The Commission has issued the enclosed Amendment No. 8, Technical Specification Change No. 18 for License No. DPR-38; Amendment No. 8, Technical Specification Change No. 13 for License No. DPR-47; and Amendment No. 5, Technical Specification Change No. 5 for License No. DPR-55, for the Oconee Nuclear Station, Units 1, 2, and 3. These amendments are in response to your request dated May 9, 1975.

OCONEE NUCLEAR STATION, UNIT 3

ATTACHMENT TO LICENSE AMENDMENTS

SAFETY EVALUATION BY THE OFFICE OF NUCLEAR REACTOR REGULATION

Figure 3.5.2-1C3

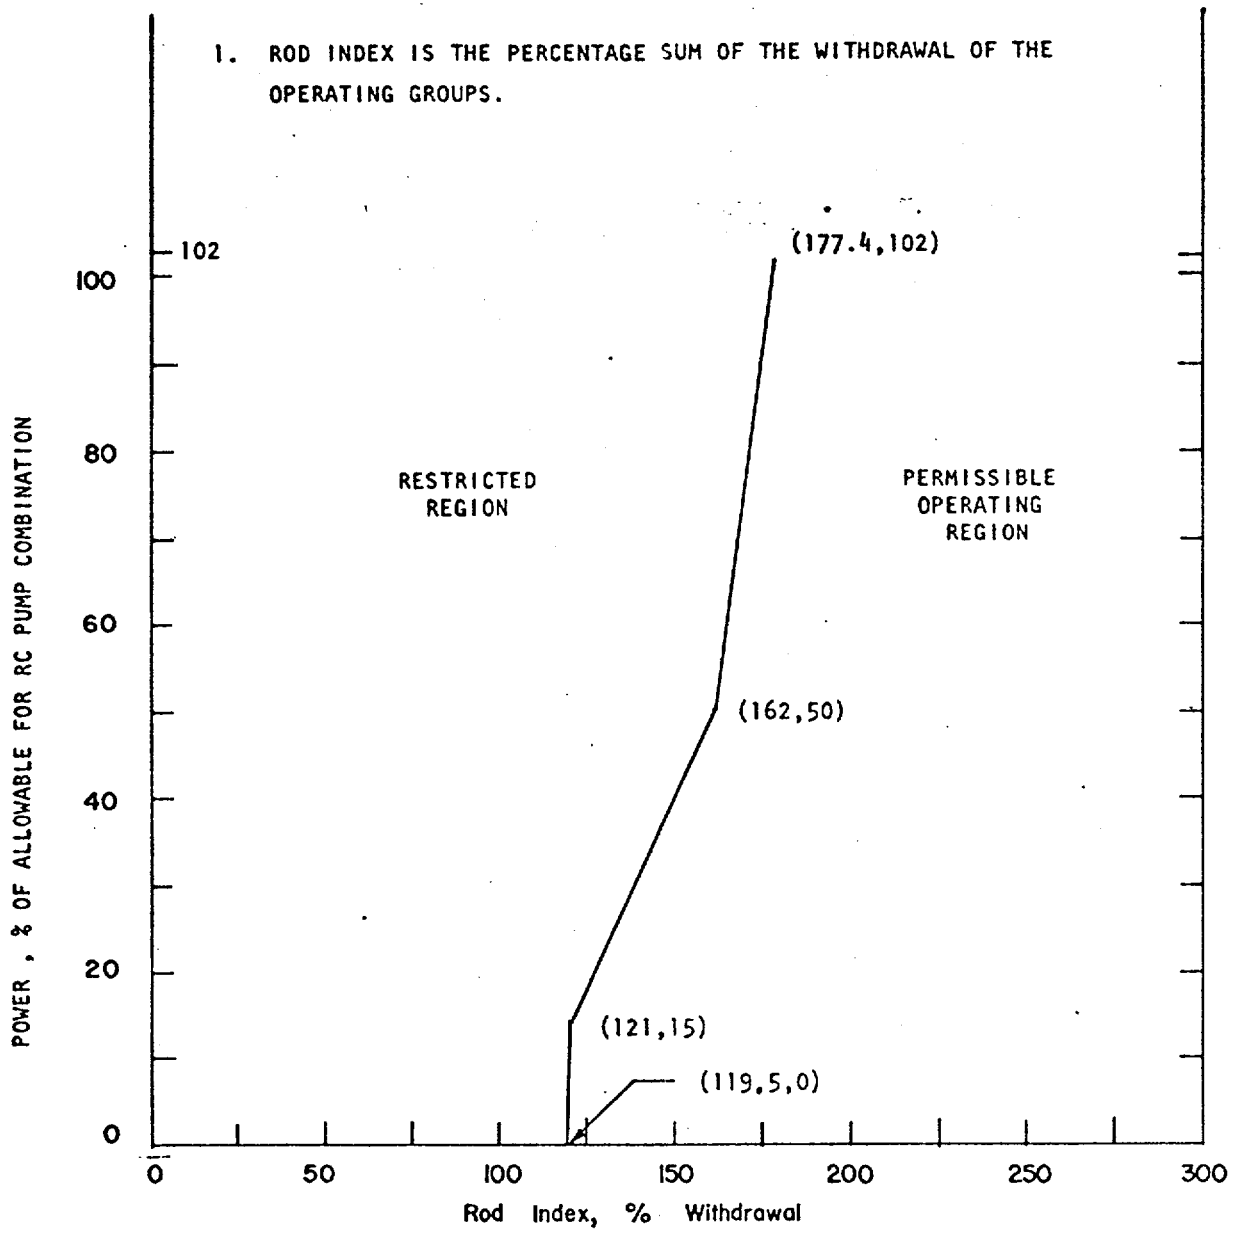
1. ROD INDEX IS THE PERCENTAGE SUM OF THE WITHDRAWAL OF THE OPERATING GROUPS.
2. THE ADDITIONAL RESTRICTIONS ON WITHDRAWAL ARE IN EFFECT AFTER 435 FULL DAYS POWER OF OPERATION.
